# Rezoning Transportation Analysis

Petition Number: #2021-277

Date	Description
05-18-2022	First Review (WB)
09-21-2022	Second Review (AO)

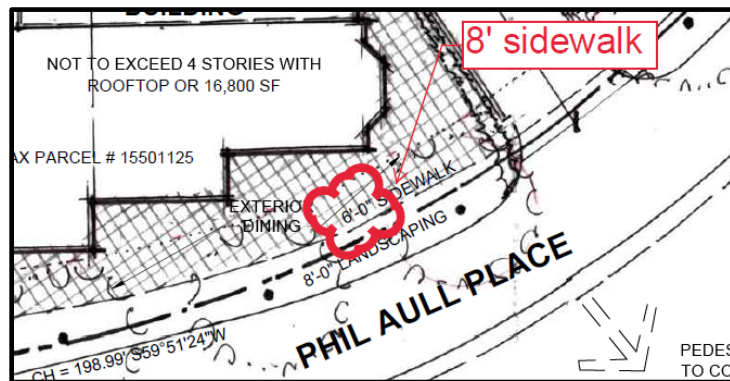
### 3. **Outstanding Comment from 5-18-22:** Revise site plan and conditional notes to commit to dedicate 40-ft (min) right-of-way from the Providence Road centerline. Provide a sidewalk utility easement (SUE) 2-ft behind the future back of sidewalk (50.5-ft from the centerline). The site plan shall label and dimension the right-of-way from the road centerline.

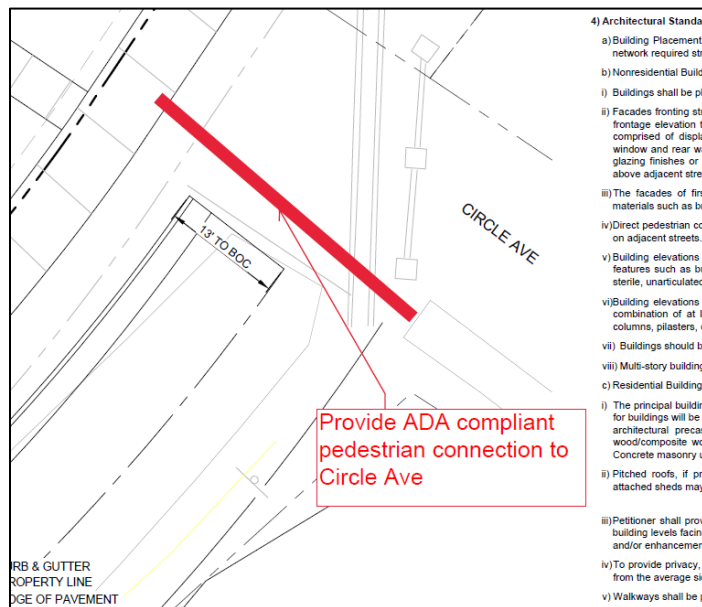
### 4. **Outstanding Comment from 5-18-22:** Revise site plan and conditional notes to commit to dedicate 28.5-ft (min) right-of-way from the Phill Aull Place centerline per CLDSM U-05A. The site plan shall label and dimension the right-of-way from the road centerline. Site plan shows 27.5-ft from Phil Aull Place centerline.

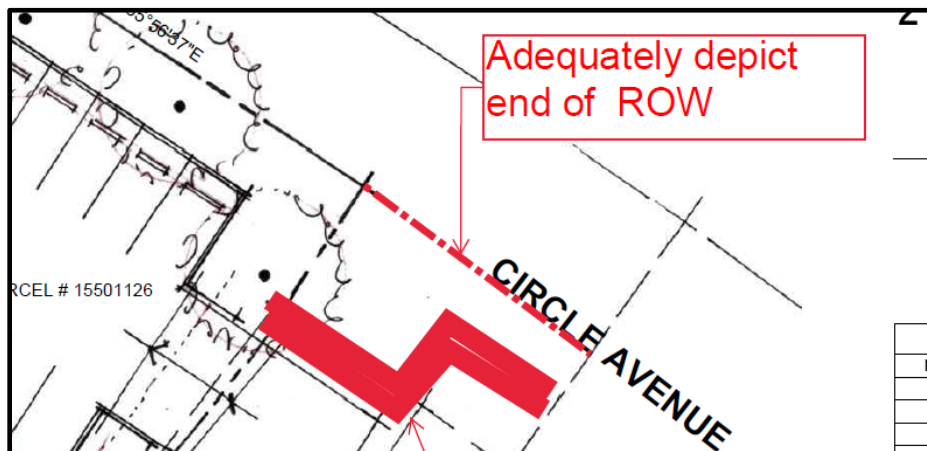
6. **Outstanding Comment from 5-18-22:** Site plan and conditional notes revisions are needed to provide an ADA compliant pedestrian connection from Phill Aull Place to Circle Avenue.
